**EVALUATION OF THE SAFETY ANALYSIS REPORT
FOR THE WASTE ISOLATION PILOT PLANT PROJECT**

Marshall S. Little

**Environmental Evaluation Group
Environmental Improvement Division
Health and Environment Department
State of New Mexico**

May. 1985

Figure 2.7-23 Structure Contours on Top of Castile Formation

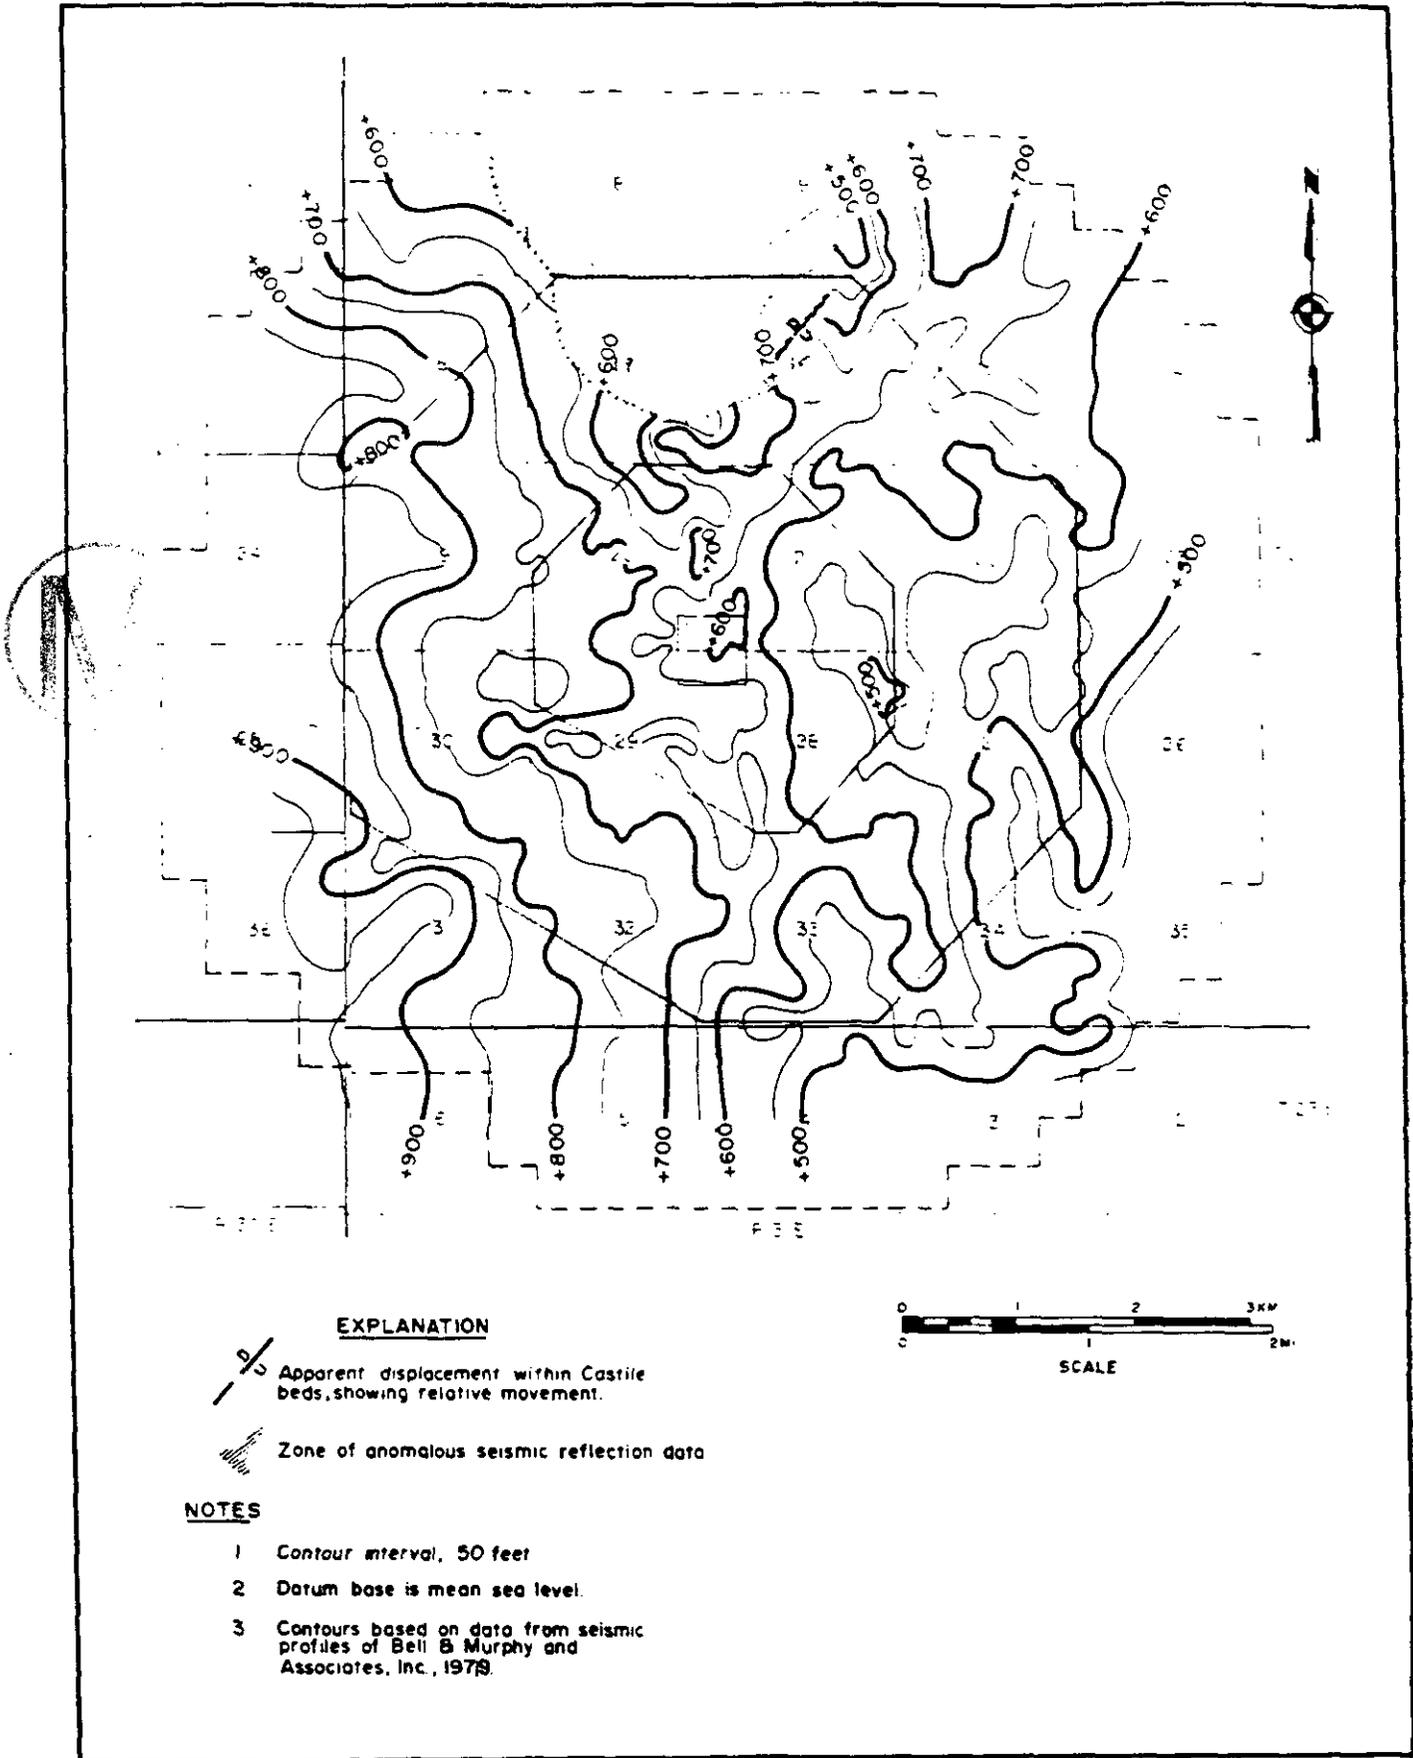
EEG called attention to the inaccuracies of the SAR's data and discussion with respect to numerous brine reservoirs in the Castile formation and their location and possible interconnection.

Certain of the reservoirs may be interconnected and cover a broad area including the WIPP site, however the data on the reservoirs at ERDA-6 and WIPP-12 suggest that these reservoirs are not connected. There remains the possibility that the WIPP-12 brine extends beneath the WIPP repository.

DOE responded by deleting Figures 2.7-23, 2.7-24, and 2.7-25, on the basis of Westinghouse "reinterpreting" the seismic profile data. The "disturbed zone" was considered a misnomer, and instead the zone was referred to as an "anomalous zone." The fact that the disturbed area did not extend into the Salado was considered by DOE to be evidence that it was not active "instability" and therefore would present no threat to WIPP. The MB-124 depression and the WIPP-12 anticline also were not considered problems for WIPP but rather reflect slow geologic processes of general interest. As a result of the State/DOE
